CASE NUMBER: TM-31930

STAFF SUPPLEMENTED GRADING EXCEPTION FINDINGS:

Variance Justifications (CORRECTED) EXHIBIT L

Grading Exceptions (APPLICANTS) EXHIBIT N

LOTS 43-44

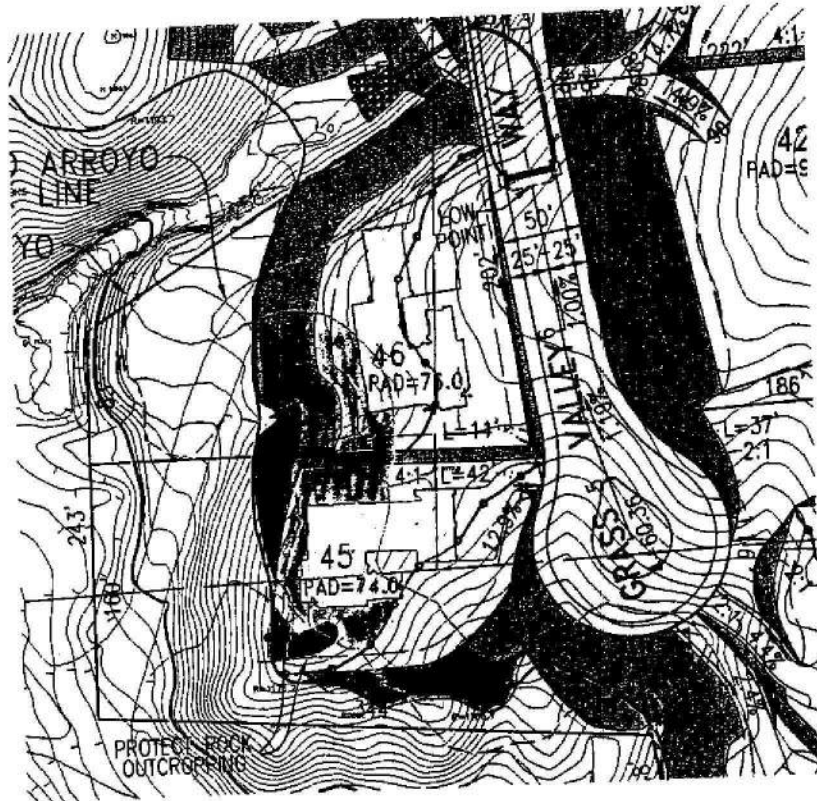
Lots 43 and 44 - The strict application of the provisions of this Title would not permit the proposed building pads in that the grading necessary for these lots encroach into the arroyo limits and setback. Based on a field inspection, staff noted that these lots are sitting on knolls above the main arroyo and are not within the arroyo. The applicant has designed the grading to daylight with no exposed slopes to the arroyo and to blend in with the natural terrain. The area directly abutting the rear property lines of these lots has been reserved as an open space lot that will link to open space areas in adjacent maps. It would be an unnecessary hardship to not permit these encroachments given that the encroachments will not affect sensitive areas of the arroyo and the actual sensitive areas behind these lots have been reserved as part of an open space lot. These encroachments will be consistent with the intent of Title 17.

Lot 43 and 44 - Per a field visit, the portions of the building pads and manufactured slopes of these lots lying within the arroyo limits and setback areas will not affect sensitive natural features of the arroyo. When staff went out to the site, it was noted that these lots are sitting on knolls above the main arroyo. The applicant has designed the grading to daylight with no visible slopes and to blend in with the natural terrain. In fact, there is a portion adjacent to the rear property line of this lot that is sensitive to the arroyo and will be reserved as part of an open space lot.

Lots 43 & 44 and Grass Valley Way- The proposed grading on this lot will not affect sensitive portions of the arroyo and no sensitive rock outcroppings within the arroyo and setbacks will be impacted. The proposed grading will have no adverse impact to this neighborhood.

LOTS 45-46

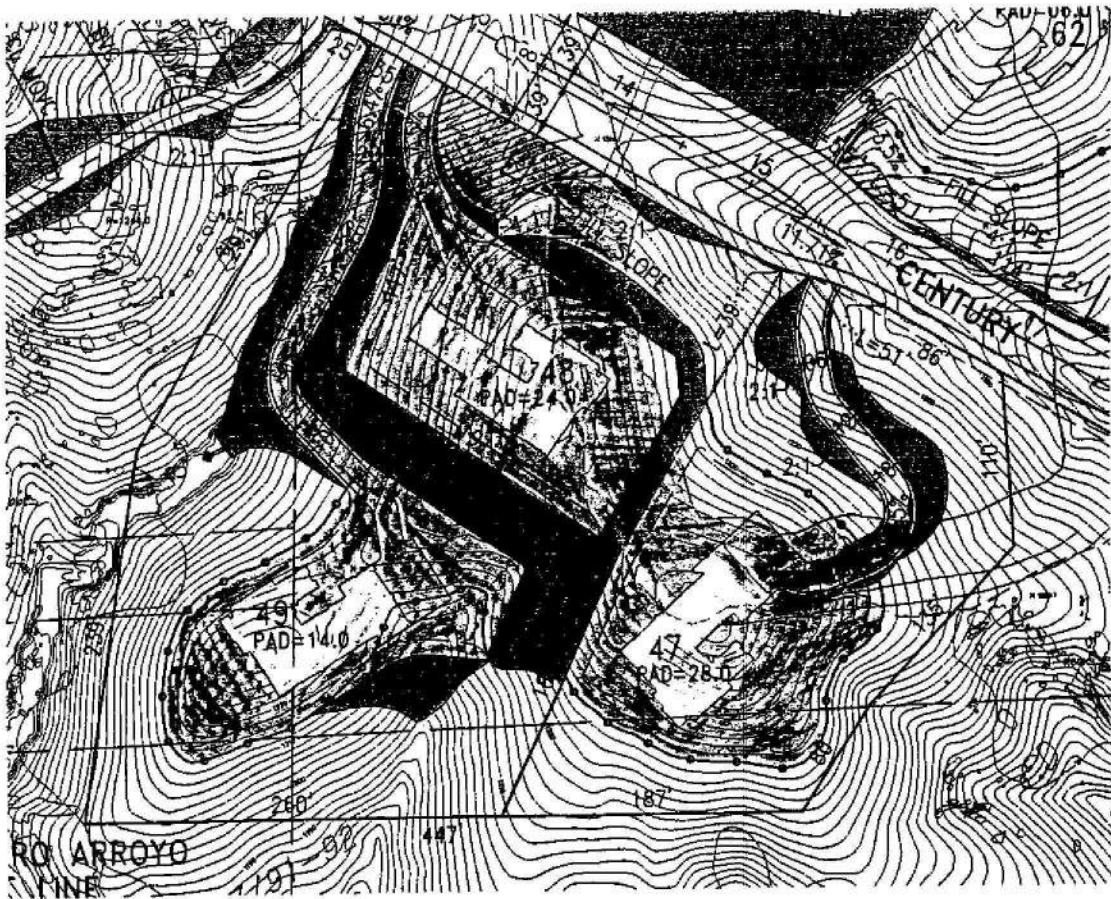
Lot 45 - The strict application of the provisions of this Title would not permit the proposed building pad in that the grading necessary for this lot encroaches into the arroyo limits and setback. The limits of the arroyo and setback were established based on an analysis of topographical maps and aerial photos which depicted those areas with slopes over 30%. Per a field visit, the proposed pad will not be situated over sensitive areas of the arroyo limits or within the arroyo itself. However, staff did note that significant rock outcroppings exist in the rear portion of the pad and are noted for protection on the map. To insure that these rock outcroppings are protected, staff is recommending that a detailed grading plan be submitted for this lot showing the precise location of these rock outcrops and insuring their preservation in order to meet the intent of Title 17. Given these circumstances, it would be an unnecessary hardship to not permit grading as proposed for this lot.

Lot 45 - As noted under finding 1, the proposed pad will not be situated over sensitive areas of the arroyo limits or within the arroyo itself. However, staff did note that significant rock outcroppings exist in the rear portion of the pad and are noted for protection on the map. Since, this grading is not actually within the arroyo, this an exceptional circumstance.

Lot 45 - The proposed grading on this lot, as conditioned for the preservation of the rock outcroppings in the rear of the pad, will not affect sensitive portions of the arroyo. On this basis, the proposed grading will have no adverse impact on the neighborhood.

LOTS 47-49

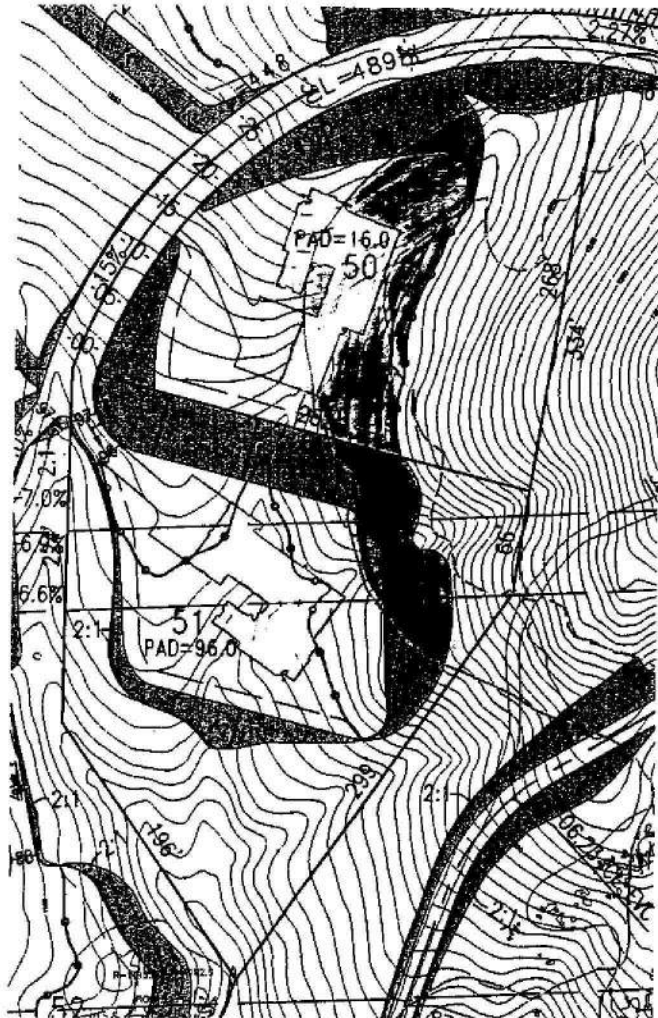
Lots 47, 48, 49, 50 and 51- These lots encroach into another tributary of the Alessandro Arroyo. This tributary extends from the arroyo to the south, northerly up a slope generally characterized with large rock outcroppings which the applicant proposes to preserve. The strict application of the provisions of this Title would not permit the proposed building pads in this location as they are within the arroyo limits and setback. However, from both a review of the grading plan as well as a field visit to the site, staff noted that these lots are not truly in the tributary but sit on a relatively flat knoll next to the tributary. The area proposed for these pads is relatively flat and does not contain any significant rock outcroppings or sensitive areas of the arroyo. In fact, there are some rock outcroppings directly easterly of lot 47 which have been reserved within an open space lot. As well, these lots have been designed to preserve significant rock outcroppings between lots 47-49 and 50-51. It would be an unnecessary hardship not to allow these minimal encroachments given that the intent of Title 17 will be met.

Lots 47, 48, 49, 50 and 51 - From both a review of the grading plan as well as a field visit to the site, staff noted that these lots are not truly in the tributary but sit out on a relatively flat knoll next to the tributary. The area proposed for these pads is relatively flat and does not contain any significant rock outcroppings or sensitive areas of the arroyo. As a matter of fact, there are some rock outcroppings directly easterly of lot 47 which have been reserved within an open space lot. Lot 48 is further to the north outside the main branch of the arroyo. As well, these lots have been designed to preserve significant rock outcroppings between lots 47-49 and 50-51. These are considered exceptional circumstances.

Lots 47, 48, 49, 50 and 51: The proposed grading on this lot, as conditioned, will not affect sensitive portions of the arroyo. This map has been approved previously and these lots will not change. The proposed grading will have no adverse impact to this neighborhood.

LOT 57

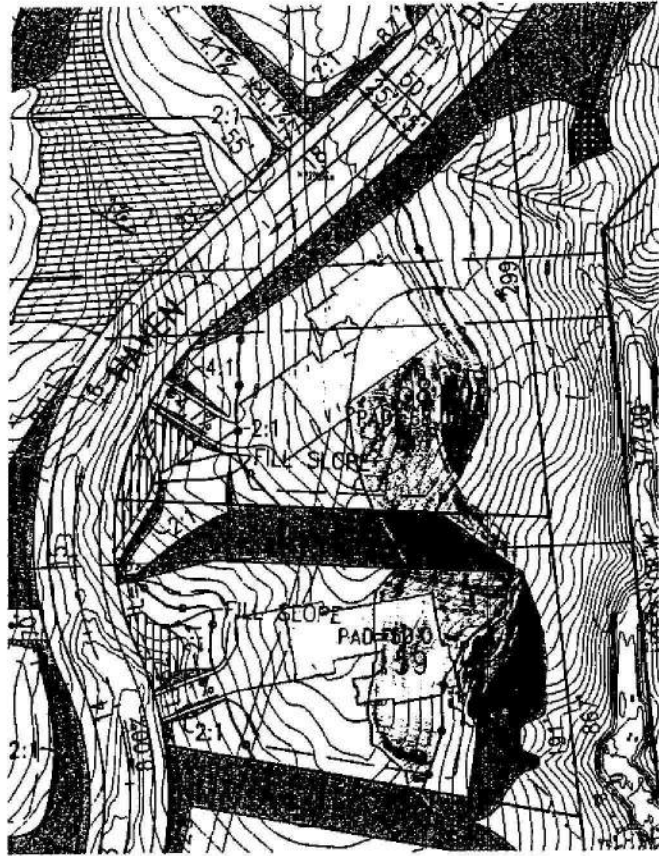
Lot 57 and Cresthaven Street - Actual grading for lot 57 has not been proposed at this time. However, a portion of lots 57 and C encroach into the arroyo and setbacks as defined by the Grading Ordinance. Therefore, the strict application of the provisions of this Title would not permit the construction of street lot C and would limit grading on lot 57. However, this area is actually just to the west of one of the tributaries of the arroyo. The areas proposed for grading do not have any of the characteristics of an arroyo. When this map was originally approved, careful

Lot 57 - This area is actually just to the west of one of the tributaries of the arroyo. The areas proposed for grading do not have any of the characteristics of an arroyo. When this map was originally, proposed careful consideration was given to the proposed street alignment through the map to insure that grading would be minimized. This portion of the site is not steep and will not impact the lower, steeper portions of this tributary. These are considered exceptional circumstances.

Lot 57 - The proposed grading on these lots will facilitate the construction of Street C which is in the least sensitive location possible. The proposed grading will not affect sensitive areas of a tributary segment of the arroyo. The proposed grading will have no adverse impact to this neighborhood.

LOTS 58-59

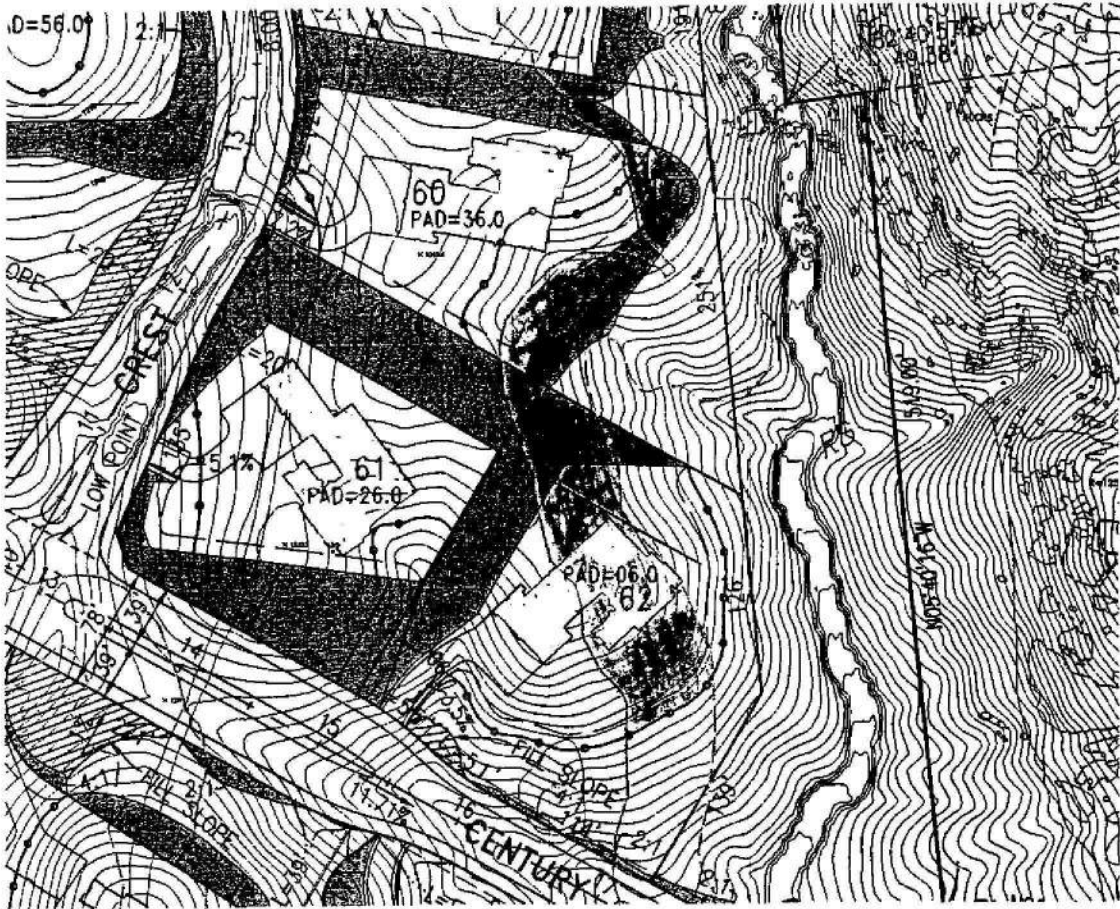
Lots 58 through 62 - Per a field visit, the proposed pads will be situated on a relatively flat area and away from the sensitive lower portion of a tributary segment of the arroyo. This is considered an exceptional circumstance.

Lots 58 through 62 - The proposed grading on these lots will not affect sensitive portions of a tributary segment of the arroyo. The proposed grading for these lots is the same as previously approved and will have no adverse impact to this neighborhood.
